Celina Fire Marshal's Office Memorandum

Top Reasons Sprinkler System Installations Fail Inspection

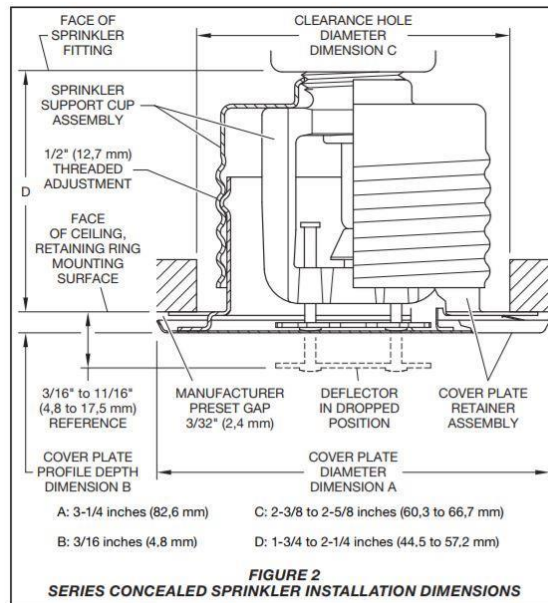
1. Failing to comply with the manufacturer's instructions for sprinkler head installation practices NFPA 13-6.2.7

Sprinkler head installations remain by far the number one reason these installations fail the acceptance inspection. Every manufacturer has installation tolerance's that are often overlooked. This is also the number one contractor contested enforcement violation.

Semi-recessed head with less than 1/2" clearance
Below ceiling surface

Concealed head with no clearance below
the ceiling surface

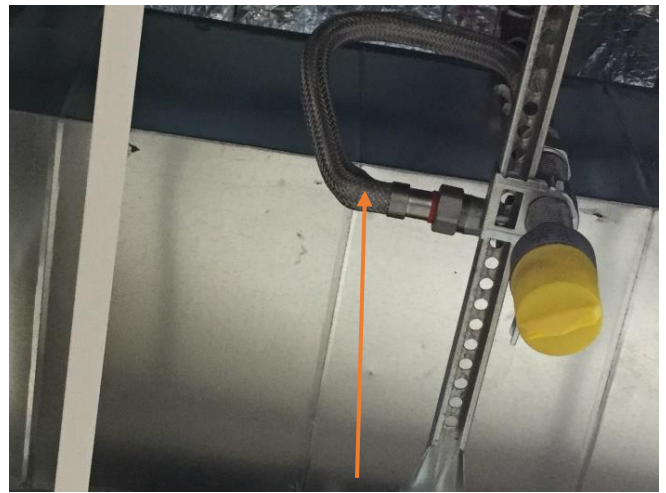
Failing to maintain the 4" minimum radius & number of bends allowed for 2' hose in violation of the U. L. Listing.

Crimped the hose during installation to achieve center tile.
